STAFF RECOMMENDATION

500 32nd Avenue South

March 15, 2017

Description of Project: Application is to retain materials installed in violation of the approved permit for infill construction.

Figure 3. The front/32nd Avenue façade drawing from the preservation permit.

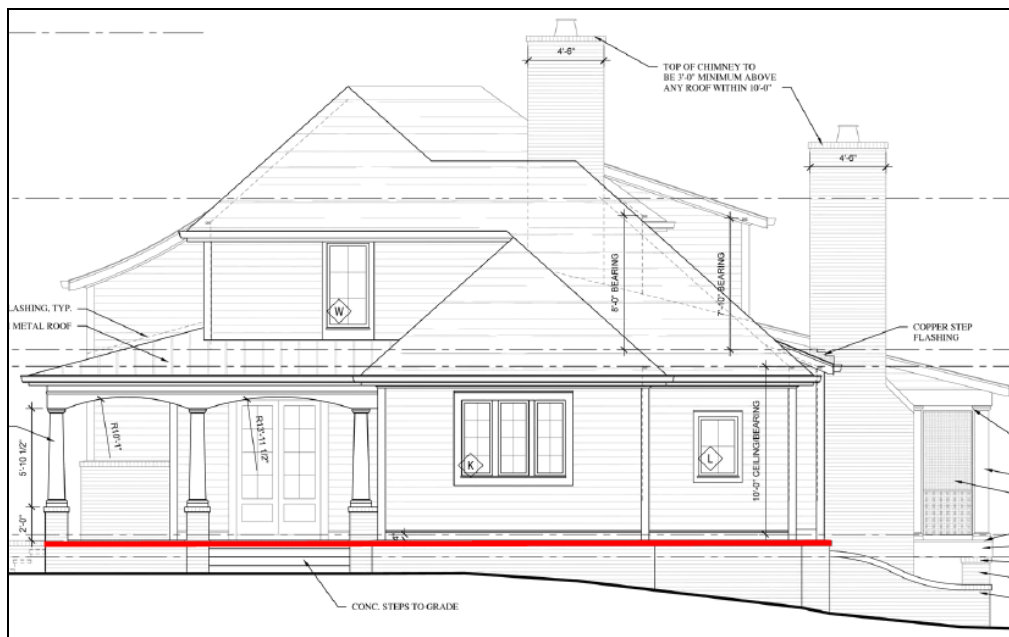
Front/32nd Avenue South Façade: On the front façade, the approved drawings show a consistent foundation line extending from the front porch over across the façade (Figure 3). However, as constructed, the foundation line to the right of the porch is lower (Figure 4). Staff recommends that the foundation line be raised to the right of the porch to provide a consistent line.

Figure 5. The Blakemore Avenue side façade drawing from the preservation permit.

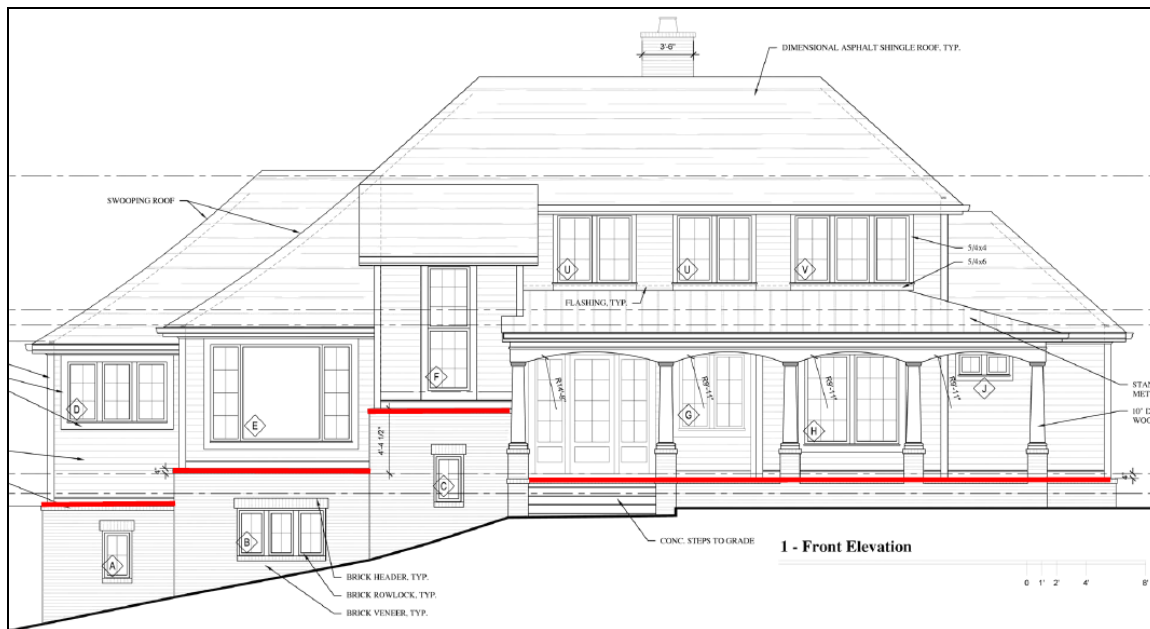
Blakemore Side Façade. The approved Blakemore side façade drawings shows that foundation line steps up after the porch for the two story bay and then steps back down (Figure 5). This stepping of the foundation helps to decrease the perceived height of the structure, specifically the projecting bay. The site slopes significantly towards the back, making this area highly visible. However, as constructed, the foundation height is lower, which increases the perceived height and scale of the infill (Figure 6). Staff recommends that the applicant bring the foundation line up and step it to be more in keeping with the approved plans. It is Staff's understanding that the applicant has agreed to make this change.
